CHANGE ORDER

PROJECT: Northern Region Pumping Facility

CHANGE ORDER NO.: 5 (Five)

PROJECT NO. : WUD 06-050

TO: Homer Gregorian, John J. Kirlin
FROM: Bruce M. Wundrack, PE
DATE: April 7, 2008
SUBJECT: Request for Proposal #14 revised
Fire Rated Windows

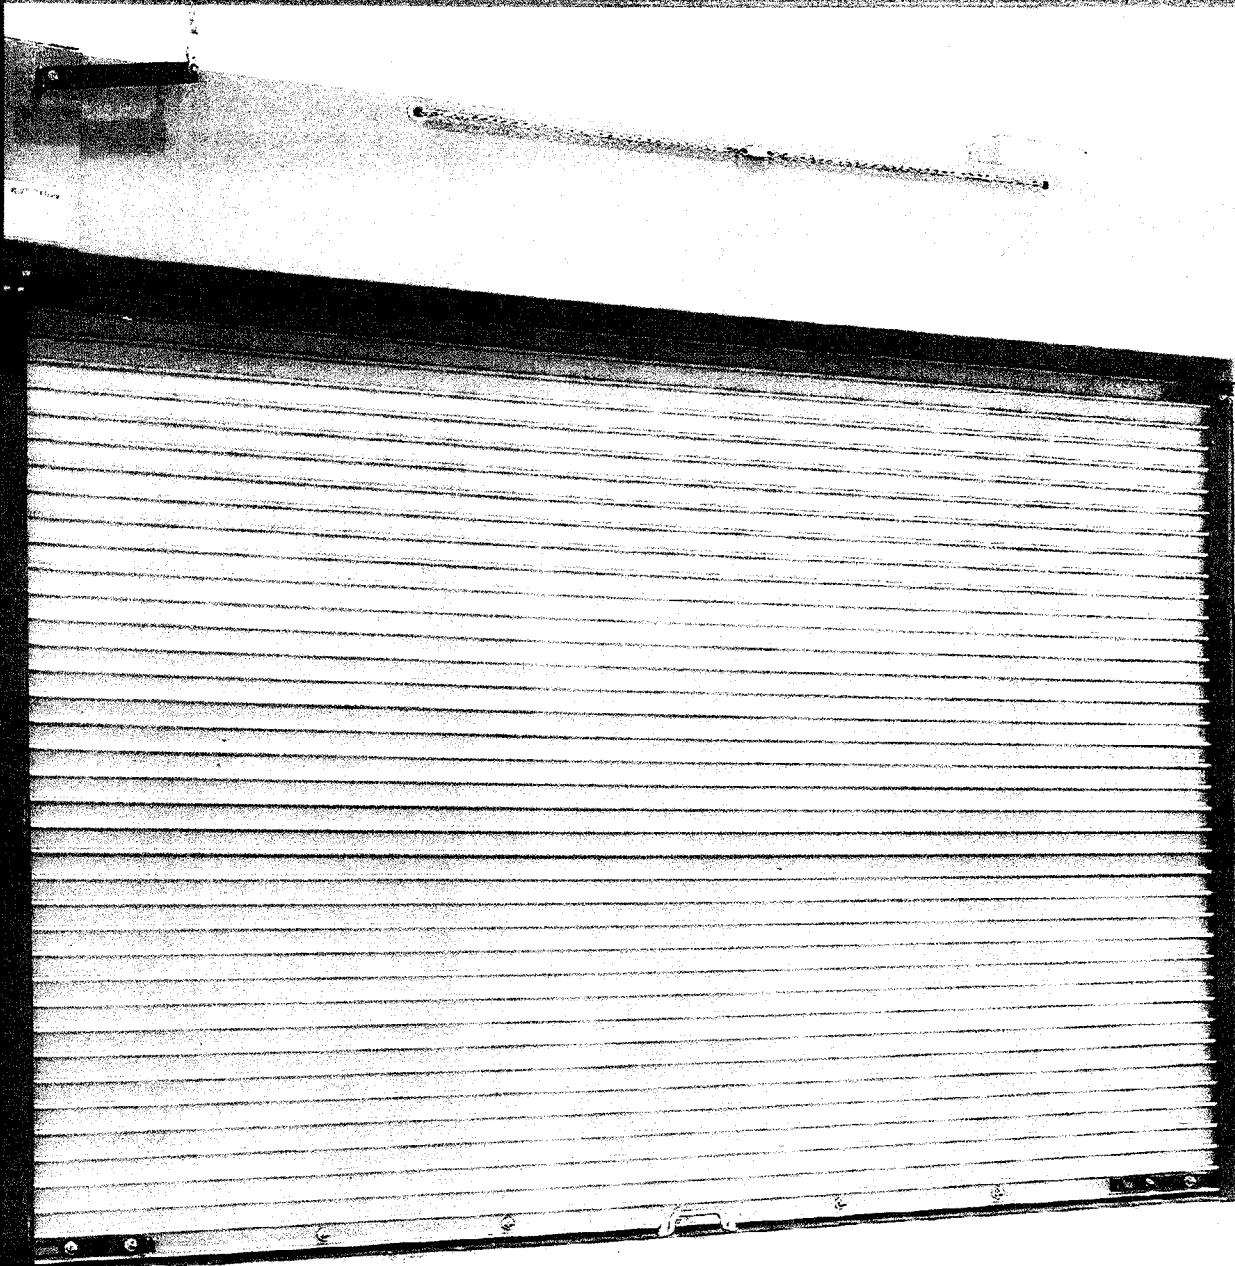
- 1- Add a 1 ½ hour rated shutter to cover window W3 at the electric room. Install the shutter on the electric room side of the window. Shutter shall be Overhead Door Series 640 with fusible link trigger for automatic operation, per the attached specifications. Finish shall be galvanized w/ optional powder coat top coat.
- 2- Remove and replace the glazing in the electrical room doors with 90 minute rated glazing. See the attached for specifications and source of the components. [3/21- Use the revised specifications attached. The same sketch applies]
